Two proposals in ChengDu and the path forward for ONU power management simplification

Denis Khotimsky
ZTE

What D72 seems to propose

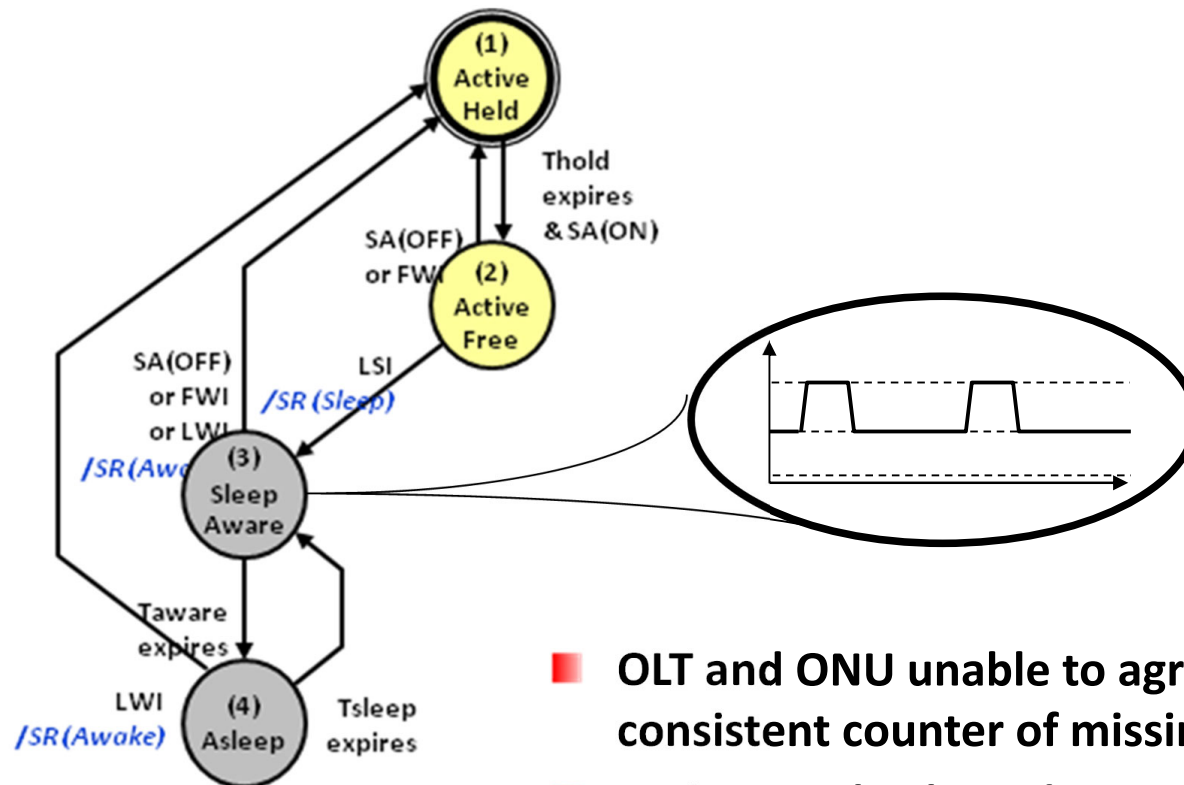
- Clobi specified in AwakeForced only!
- Outside of the Power Saving phase

What D72 likely meant to propose

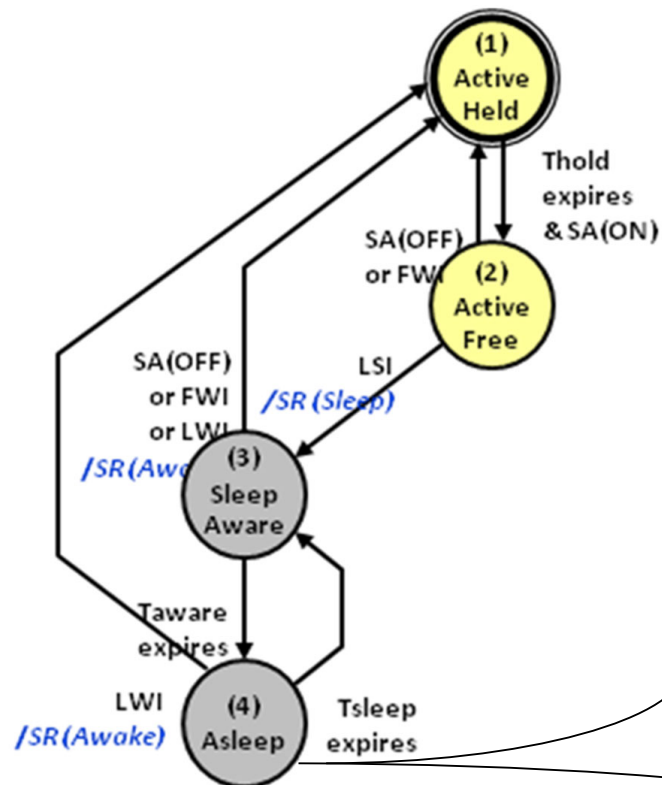
- OLT and ONU unable to agree on consistent counter of missing bursts
- Major non-backward-compatible protocol change in the Aware state

What D72 might have proposed

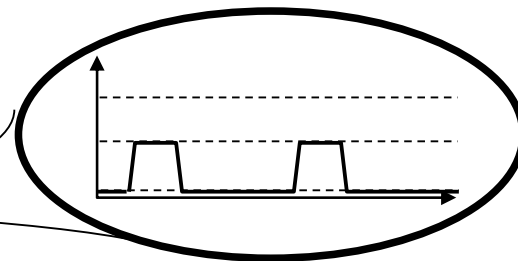
- Transitions timer-driven as in original G.987.3
- A change to the internal state semantics, but not to the protocol
- Need a transition out of Low Power state on external stimulus (missing in the Sleep branch)!

What should be done

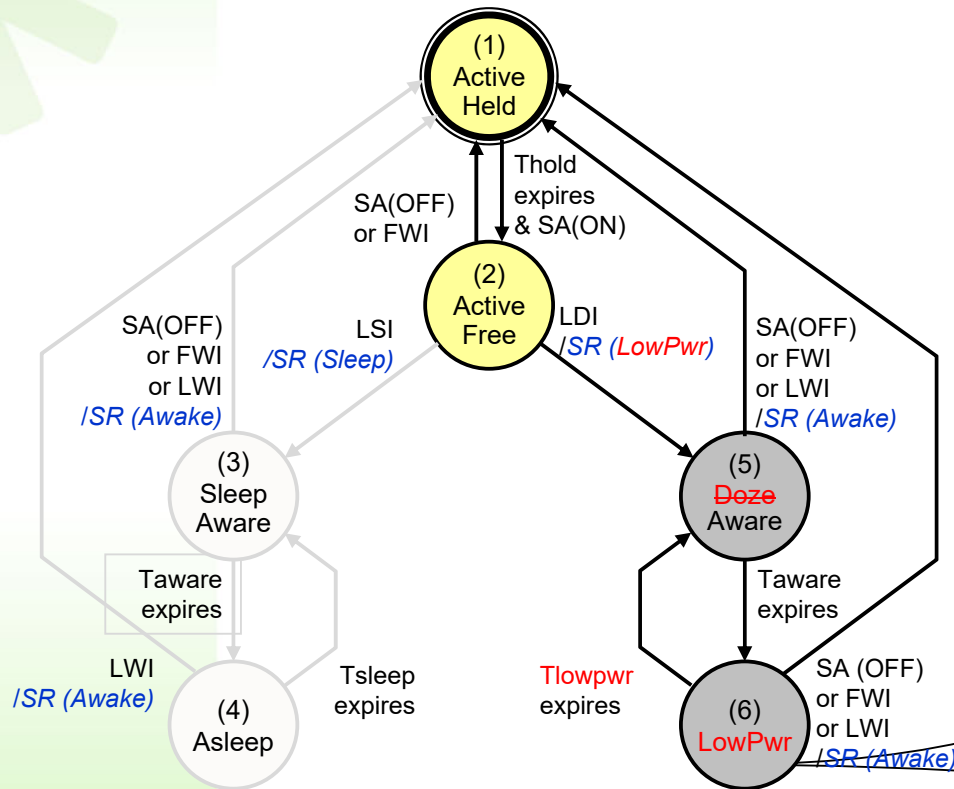
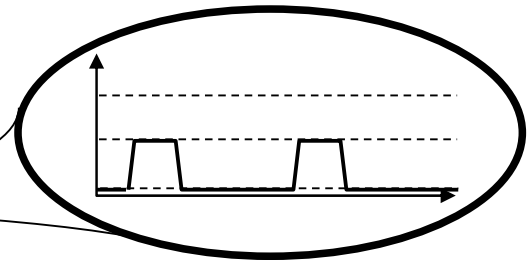
- Reusing mandatory branch of G.987.3!
- A change to the internal state semantics , not to the protocol
- A transition out of Low Power state is present!
- Since only one branch is left, does not matter whether it is called Sleep or Doze: it is Unified mode!
